McCULLOCH SERVICE BULLETIN

NO. [redacted] 1666

DATE June 12, 1978

SUBJECT 1. Corrections to ADV 140014-R6 Price List.
2. Spark Plug Thread Repair Kit, P/N 92125.
3. Flywheel Assembly, P/N 86068A (24-Fin).
4. Pro Mac 610/650 IPL Corrections.
5. Trigger Release Assembly, P/N 94275.

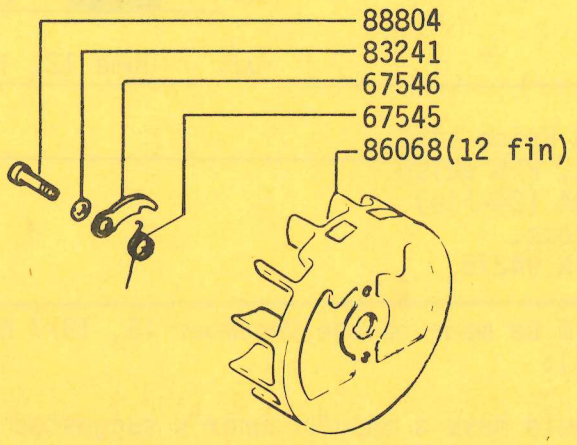
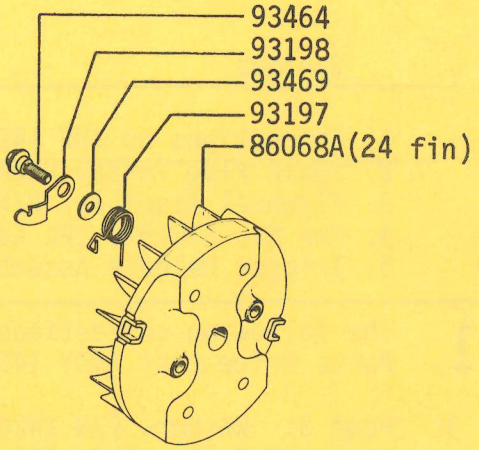
3. Flywheel Assembly, P/N 86068A, which includes a 24-fin flywheel, is now available as service replacement on Pro Mac 10-10, 555, 700 and 850 chain saws. The 12-fin and 24-fin flywheels can be used interchangeably on these 10-series models. However, the assembly components are not interchangeable with each other. The components must be used as follows:

86068	Flywheel Assembly	86068A	
To be used only on P/N 86068 assembly	88804	. Screw - Special	93464	To be used only on P/N 86068A assembly
	67546	. Pawl - Starter	93198	
	83241	. Washer - Special	93469	
	67545	. Spring - Pawls	93197
